**Subject: Annual Inspection Report**  
**Marion County – Rankin Fite Airport (HAB)**

# Annual Inspection Report

***Marion County – Rankin Fite Airport  
(HAB)  
Hamilton, Alabama***

Photo #1 – Runway 18 Approach

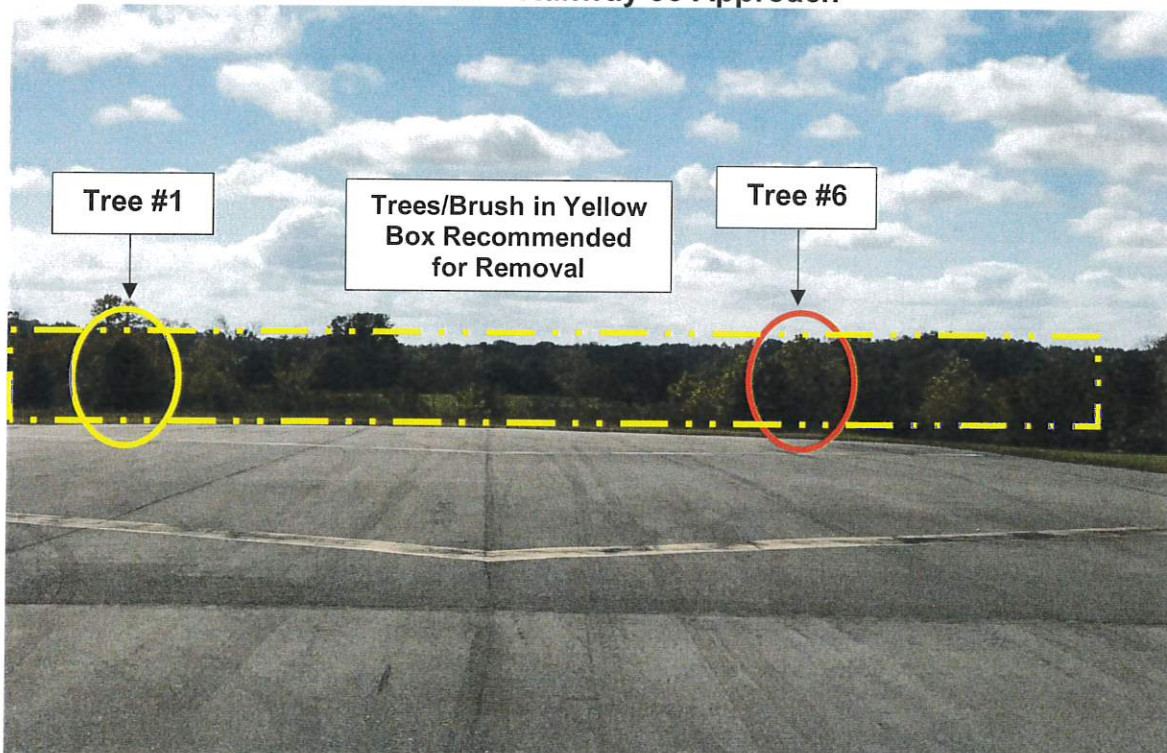
- Runway 18– No obstructions (See Photo #1).
- Runway 36 – Tree labeled #6 violates the Required 20:1 Approach and Departure Path. Tree labeled #1 is not an ALDOT obstruction violation, however, it will be very soon if not removed. Trees and shrubs in yellow dashed box are recommended for removal to prevent future obstructions (See Photo #2 and Appendix 2).

Photo #8 – Wind Direction Indicator

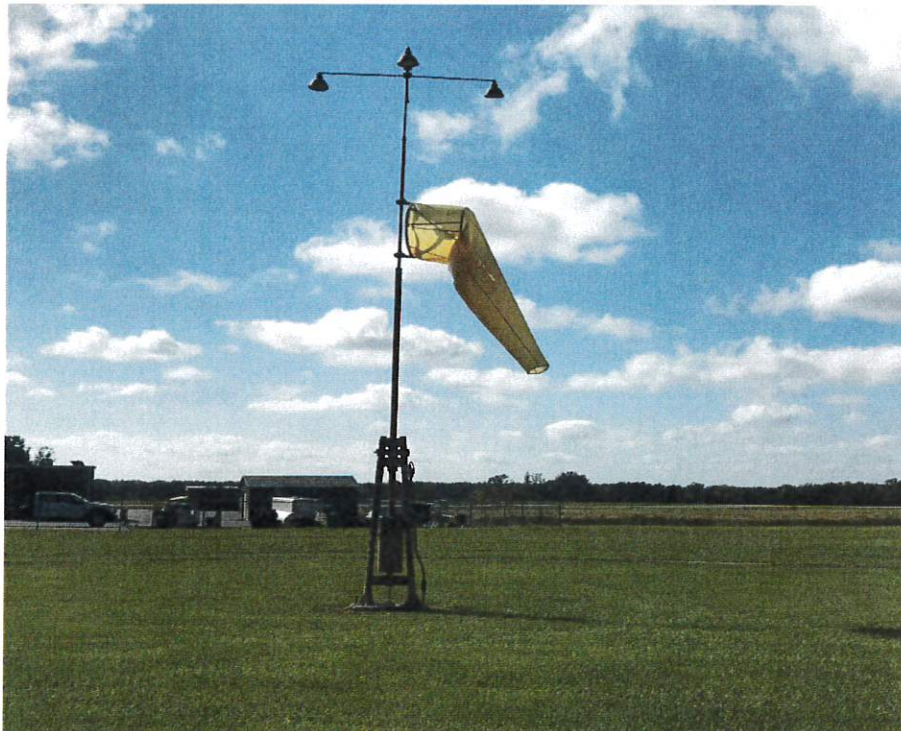
- The wind direction indicator is in **POOR** condition due to fading (See Photo #8).
- One light from the fixture is missing, but a repair was already scheduled.
- Segmented circle is faded.

- Replace windsock.
- Repair light- was underway.
- Repaint segmented circle white.

**HAMILTON-RANKIN FITE AIRPORT  
HAMILTON, AL  
OCTOBER 22, 2020  
RWY 36 OBSTRUCTION EVALUATION**

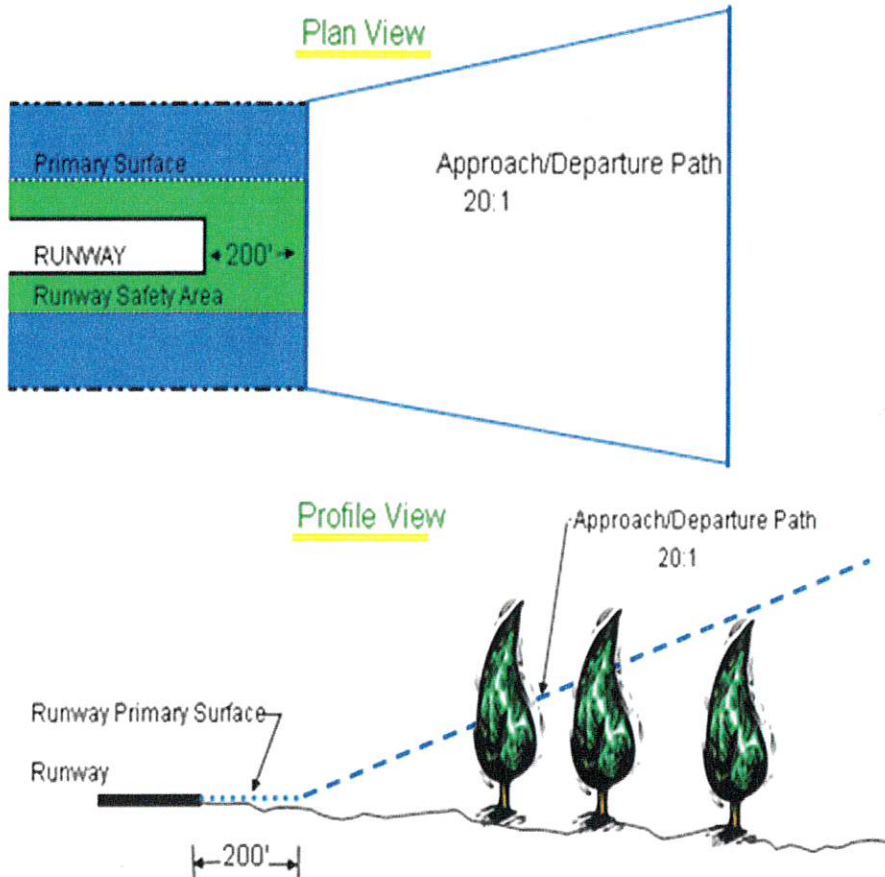
1. Tree 23' Abv. RWY End  
678' From RWY End  
106' Right of Cntln.  
20:1 Obst. Clnc.  
• Not an ALDOT Violation
6. Tree 21' Abv. RWY End  
588' From RWY End  
79' Left of Cntln.  
18:1 Obst. Clnc.

- Remove all obstructions to the Required 20:1 Approach and Departure Path.
- *Note: The obstructions detailed in this report are representative and may not include all obstructions in the Approach and Departure Path.*
